## **TECHNICAL BULLETIN**

**429-21-65**

**SUBJECT:** MISSING DECALS ON FIREWALL 429-069-101-187, INSPECTION AND INSTALLATION OF

**HELICOPTERS AFFECTED:** Serial numbers 57001 through 57384, 57386, 57388, 57389, 57392 and 57395

**Figure 1 –Missing Decal on Forward Firewall**

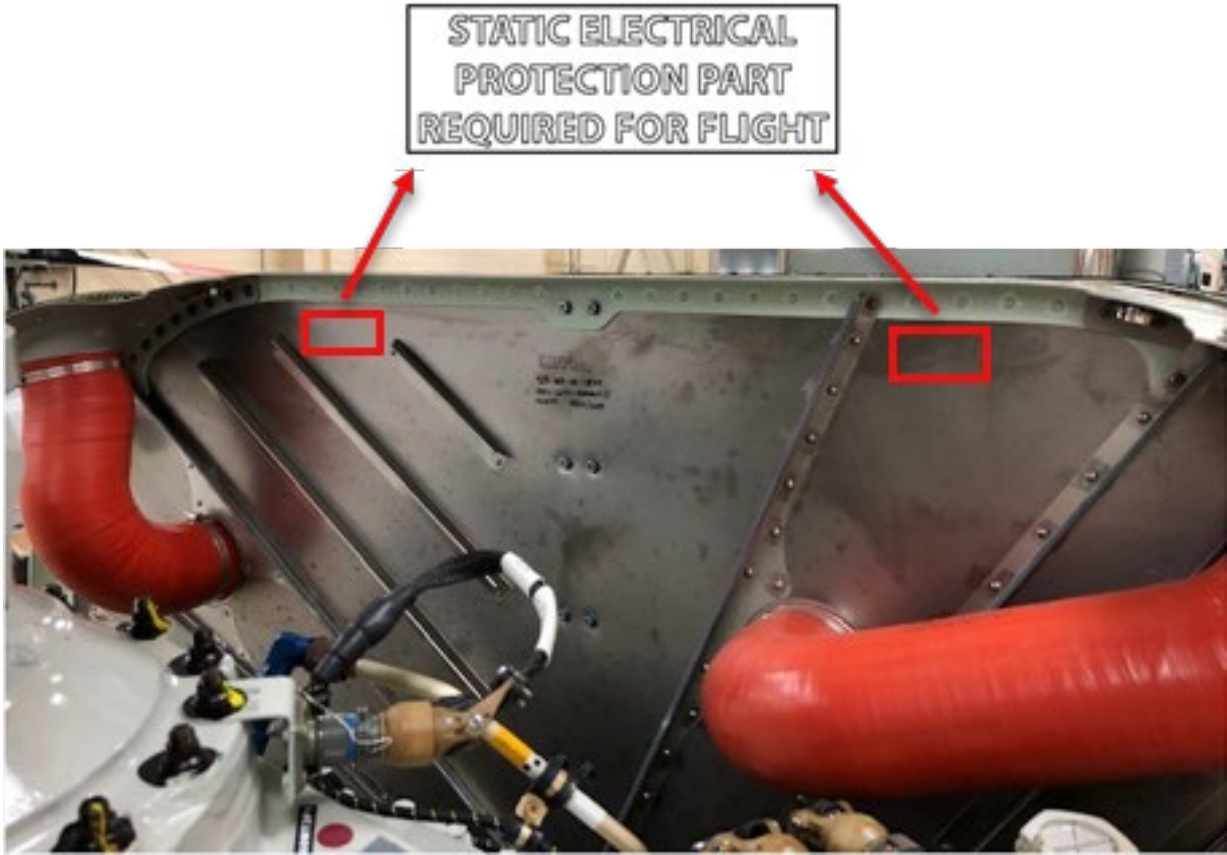
Bell recently discovered that two decals 31-055-19DMHP may have been inadvertently omitted from the forward firewall 429-069-101-187 during manufacturing. This Technical Bulletin (TB) provides procedures to inspect for the required decals and install if missing. The purpose of these decals is to remind operators that access panels 429-061-201-101 and -103 are static electrical protection parts and are required for flight. The approved engineering configuration requires these decals to be installed on the adjacent structure of the access panels, which is the subject firewall.

1. Prepare the helicopter for maintenance.
2. Remove the transmission cowl assembly 600EL and 600ER. (DMC-429-A-53-00-00-46A-520A-A)
3. Check for the presence of two decals 31-055-19DMHP on the forward firewall 429-069-101-187 per figure 1. If the decals are present, go to step 5.

Locations of the decals are shown in figure 1. They need to be clearly visible after installation. The receiving surface must be free of dirt, grease, wax and other contaminants.

4. Install two decals onto the forward firewall 429-069-101-187. (DMC-429-A-11-00-00-00A-067A-A)
5. Reinstall the transmission cowl assembly 600EL and 600ER. (DMC-429-A-53-00-00-46A-520A-A)
6. Make an entry in the helicopter logbook and historical service records indicating compliance with this Technical Bulletin.
